CRICHTON COMMERCE PLACE SUBDIVISION, RESUBDIVISION OF & ADDITION TO

APPLICATION NUMBER 13 DATE January 21, 2010

REQUEST Subdivision

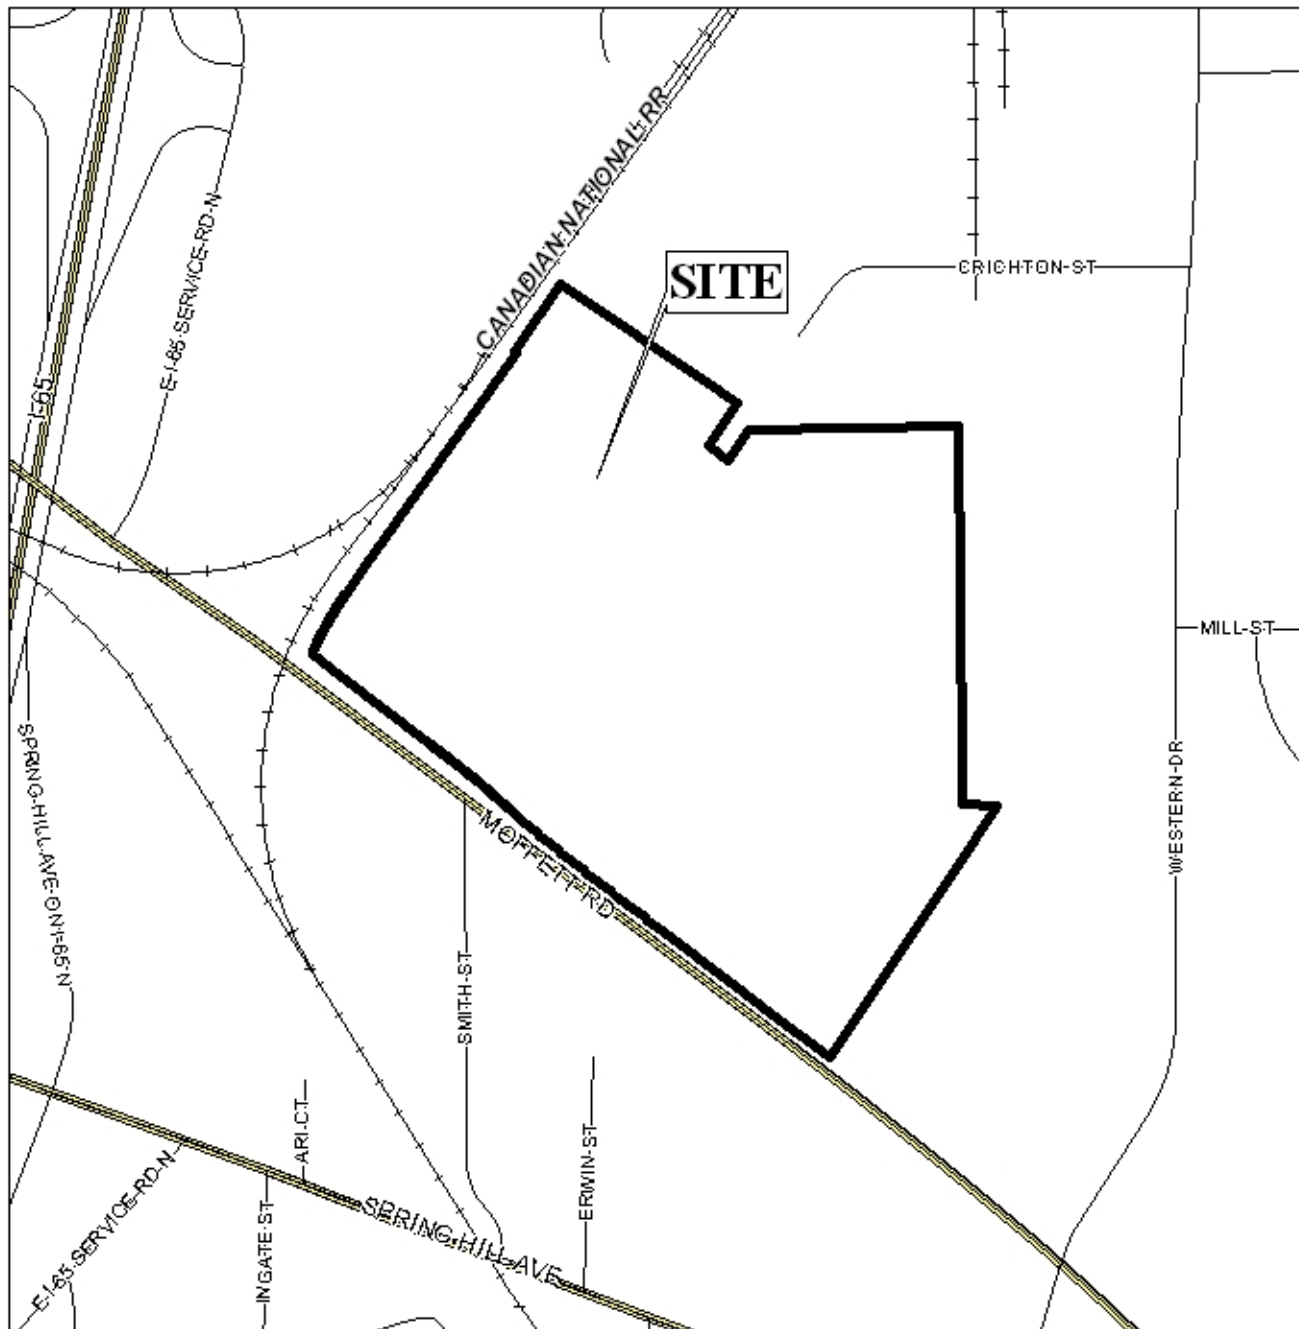
Engineering Comments: Need to construct a City standard cul-de sac and provide a minimum of 120' radius for ROW. Need to provide detention (to be maintained by Developer/Property Owner and not City of Mobile) for the increase in pavement surface and provide a drainage easement for the discharge of public water from the newly constructed cul-de sac. The receiving storm drainage system will need to be analyzed to show that it has the capacity and functionality to receive drainage from the proposed development. Must comply with all storm water and flood control ordinances. Any increase in impervious area in excess of 4,000 square feet will require detention. Any work performed in the right of way will require a right of way permit. Drainage from any new dumpster pads cannot discharge to storm sewer; must have connection to sanitary sewer.

The site fronts on Moffett Road which is a component of the Major Street Plan with a current compliant 100' right-of-way; therefore, no dedication would be required. To the North, the site fronts along the East and West sides of Crichton Street, an unopened and unimproved public right-of-way along the site, which is proposed to be vacated to approximately 720' North of its South terminus. The remainder of Crichton Street along the site has a compliant 50' right-of-way, but is unopened and unimproved for approximately 300' North of the proposed section to be vacated. As a fire apparatus access road is proposed from Crichton Street into proposed Lot 2, the unopened and unimproved portion of Crichton Street North of the vacated portion should

As a means of access management, a note should be required on the Final Plat stating that the driveway number, size, location, and design are to be approved by Traffic Engineering and conform to AASHTO standards. The plat should be revised to label the lot sizes in acreage and square feet, or a table should be provided on the Final Plat furnishing the same information. As on the plat, the 25' minimum building setback line should be indicated on the Final Plat along all street frontages.

- 10) revision of the plat to include the 120' diameter cul-de-sac as required by the Engineering comments.

FIRE ACCESS ROAD

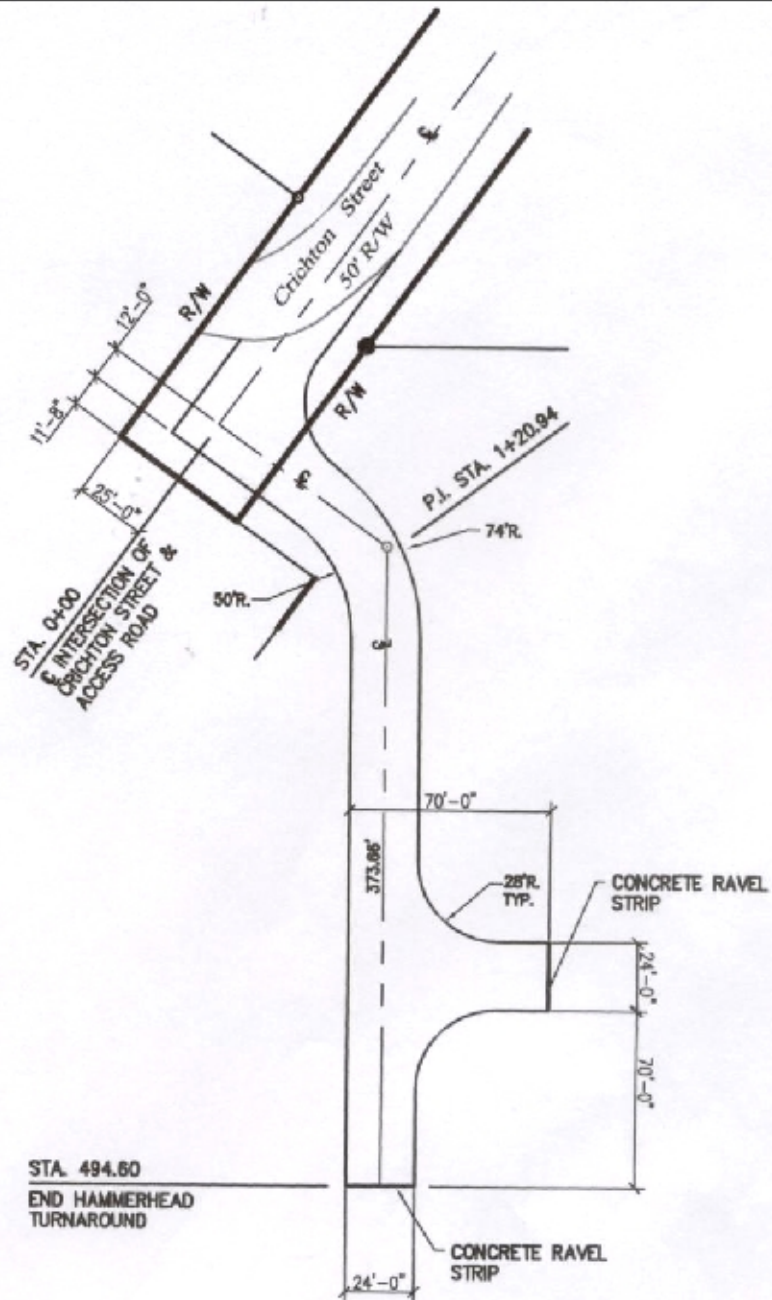
be constructed to City standards. The fire apparatus access road should be constructed to 2003 IFC Section D103 standards as shown on the plat.

- 3) construction of the fire apparatus access road on proposed Lot 2 to 2003 IFC Section D103 standards prior to signing the Final Plat;
- 4) placement of a note on the Final Plat stating that the driveway number, size, location, and design are to be approved by Traffic Engineering and conform to AASHTO standards;
